Capital Development Committee Staff — Summary of Facility Program Plan (FPP) Department of Corrections — Close Custody Outdoor Recreation Yards - Colorado State Penitentiary	
Component	Summary
Mission, Intent, and Policy Changes	<ul style="list-style-type: none"> The mission of the Department of Corrections (DOC) is "to protect the citizens of Colorado by holding offenders accountable and engaging them in opportunities to make positive behavioral changes and become law-abiding, productive citizens." The programmatic intent of the project is to physically modify and upgrade the Colorado State Penitentiary (CSP) to comply with court-decreed minimum legal standards for outdoor recreation for its new Close Custody Management Control Unit (MCU) and Close Custody Transition Unit (CCTU) classifications. All MCU and CCTU offenders will have some opportunity for group interaction, as prolonged isolation is generally not conducive to the successful reintegration of these offenders into a less controlled environment. Physical modifications at CSP are necessary to align the operations of the facility with recent changes regarding the former Administrative Segregation classification. Sterling C

CSP - SITE PLAN
 RECREATION YARD PROJECT

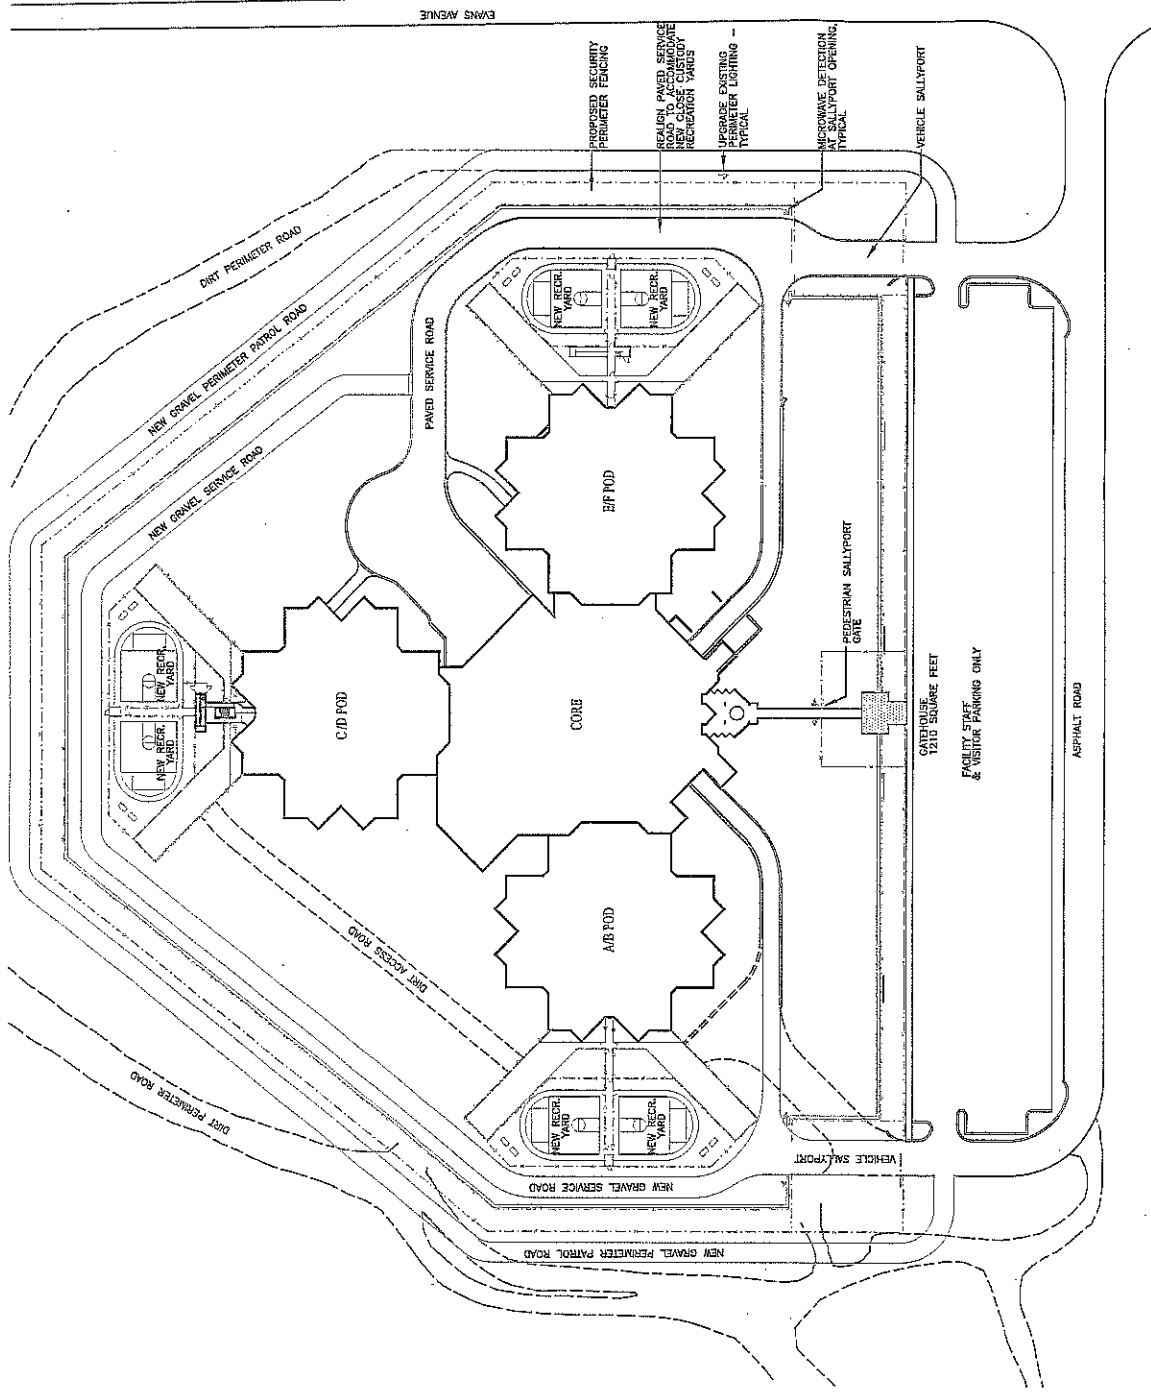
8. Why is it not practical to place the second 12-foot high security fence outside the entire length of the existing fence?

Will the appropriate level of detection and deterrence for a Level V facility be provided in the areas that do not have a double line fence?

Where there is not a second fence, will razor ribbon wire and barbed wire be added to the existing fence?

Answer: A double 12-foot high security fence surrounding the entire CSP complex has been proposed for the project; refer to "Appendix B- Preliminary Site Plan Concepts" located in the FPP. In some areas the configuration of the existing single security fence does not make it practical to install the second security fence due to security issues or limited space for the outdoor recreation yards and perimeter road. In these locations the existing single fence will need to be reconfigured to allow for sufficient installation of the second fence.

Answer: The double fence will enclose the entire perimeter and with its security features is intended to provide the appropriate level of detection and deterrence for a Level V facility when offenders are regularly outdoors in close proximity to the perimeter. The double fence line includes the following features:

- Razor ribbon wire in a coiled pyramid array at base of the new outer security fence
- Barbed wire and supports at top of new outer fence
- Horizontal concrete rat barrier inside of existing inner fence
- Two vehicle saltyports with remote operated sliding gates
- Non-lethal electrified fence (NLEF) on inner security fence.

Answer: A second fence with razor ribbon wire in a coiled pyramid array at the base of the new outer security fence is planned for the entire complex.
